**FMC Corporation**  
1735 Market Street  
Philadelphia, PA 19103  
USA

Re: Amended RCRA Post-Closure Plan - Slag Pit Sump  
FMC facility, Pocatello, Idaho - RCRA ID #IDD070929518  
Incorporation of RCRA post-closure elements with IRODA implementation

FIGURE 1

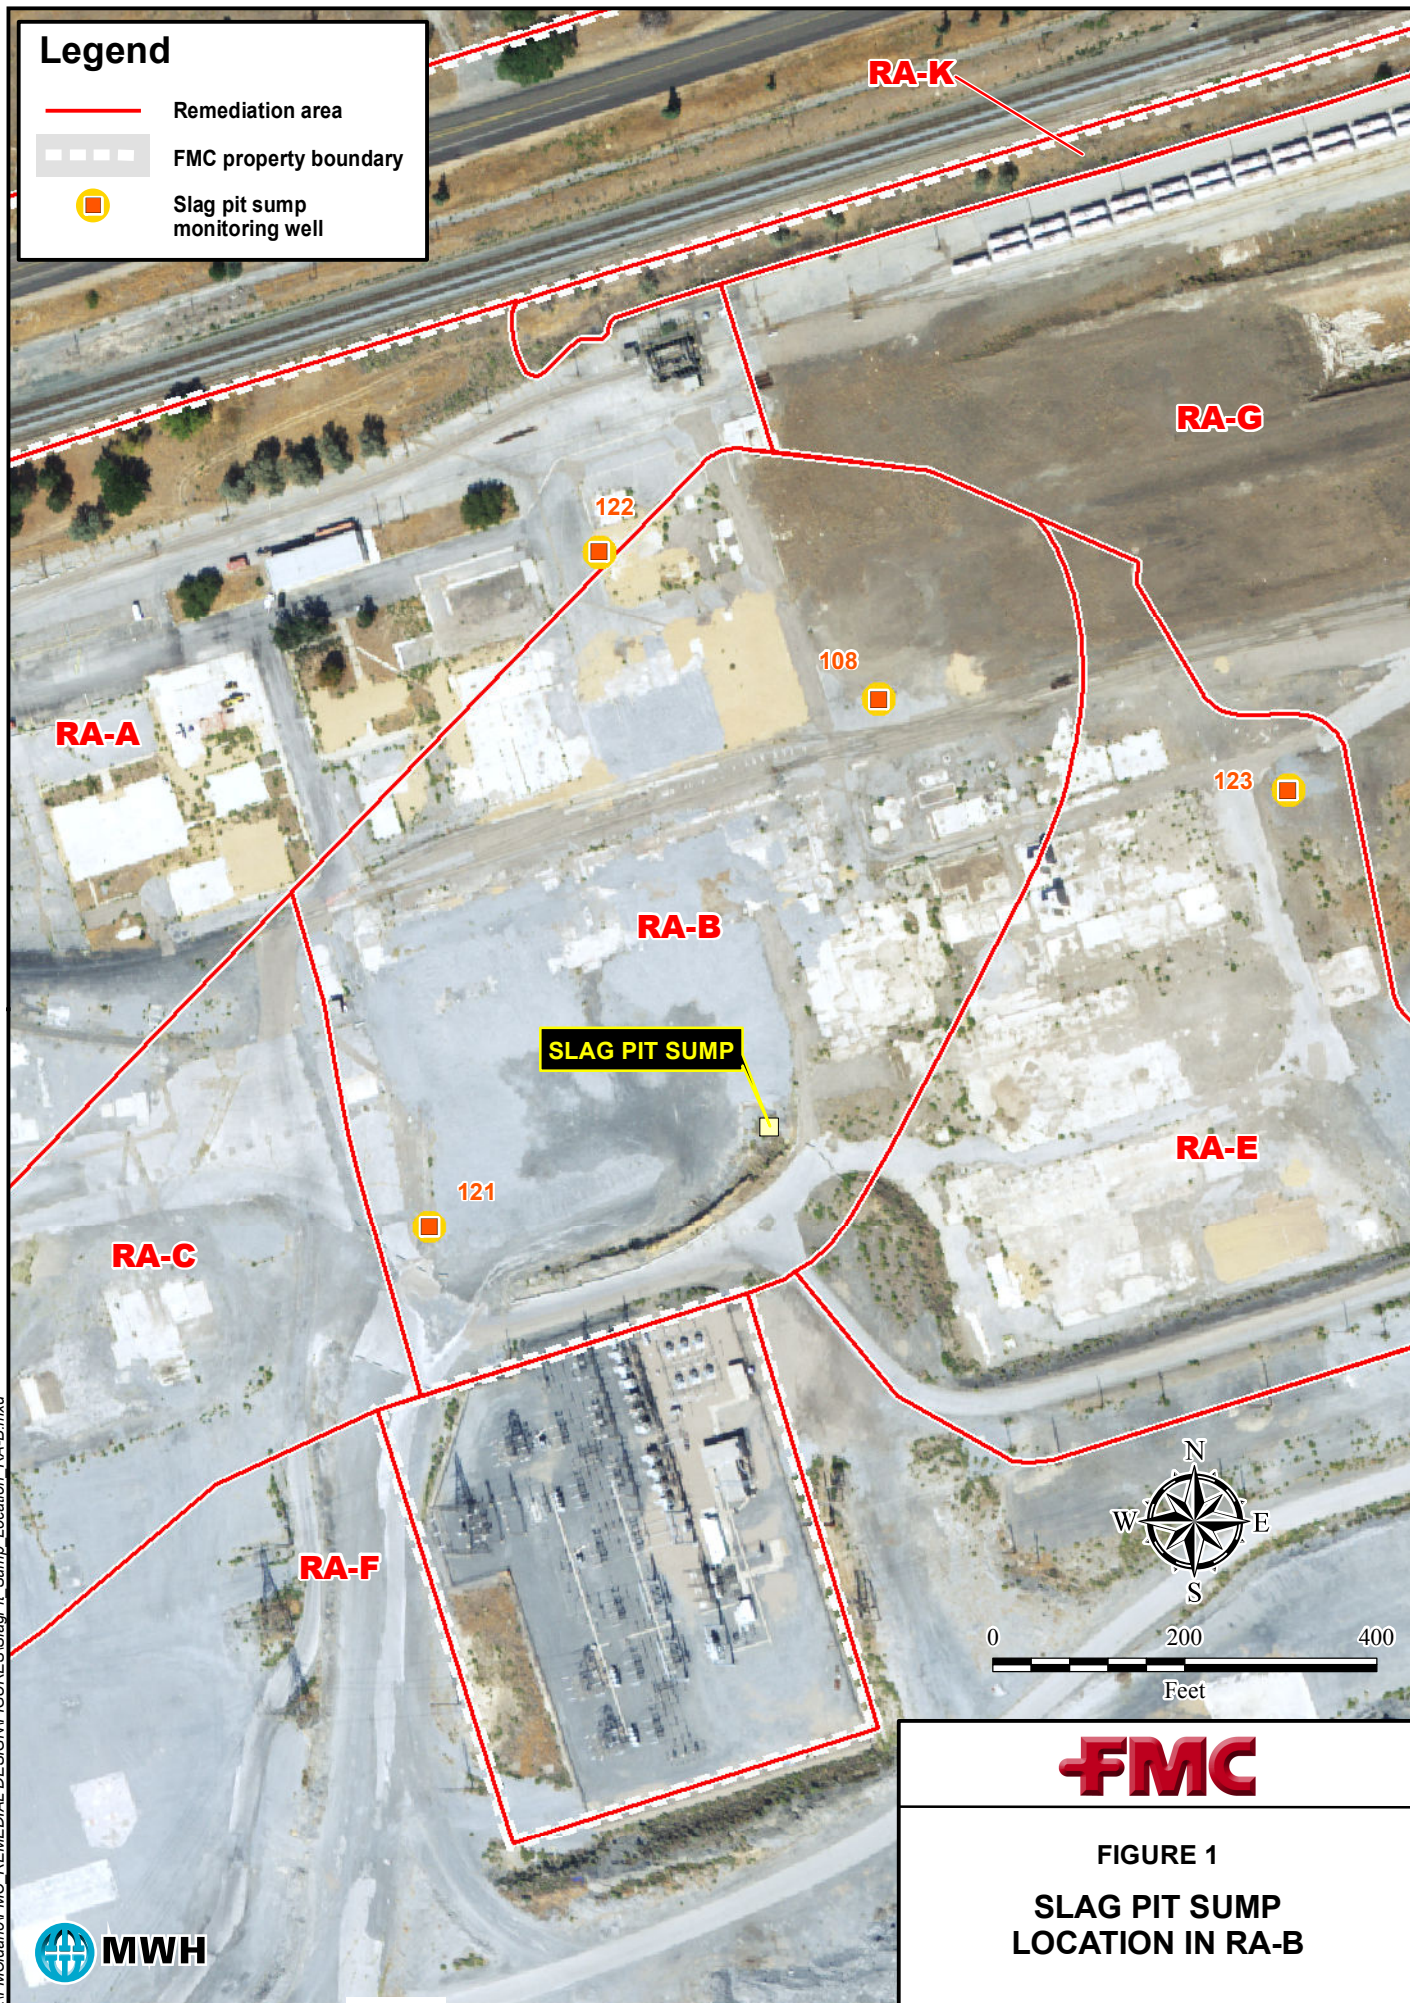
The SPS is located in the former slag pit within RA-B as shown on the attached Figure 1. In order to meet the objectives of preventing the infiltration of rainwater and preventing migration of contaminants to groundwater, the former slag pit and more generally the entire area within RA-B will be filled to the grade specified in the Remedial Design Engineering Design Submittal (submitted to EPA on July 18, 2014). This grading is designed to prevent run-on and drain precipitation laterally off of the ET cap on RA-B. Inherent in this design is the placement of more than 25 feet of fill over the closed SPS. The SPS closure caps (the interim and final asphaltic concrete caps) will remain in place. Implementation of the IRODA remedy will provide additional protectiveness to the existing SPS closure system, which was constructed to meet RCRA performance standards, and will continue to meet those standards with added protectiveness after the CERCLA-required filling, grading and installation of the ET cap is completed.
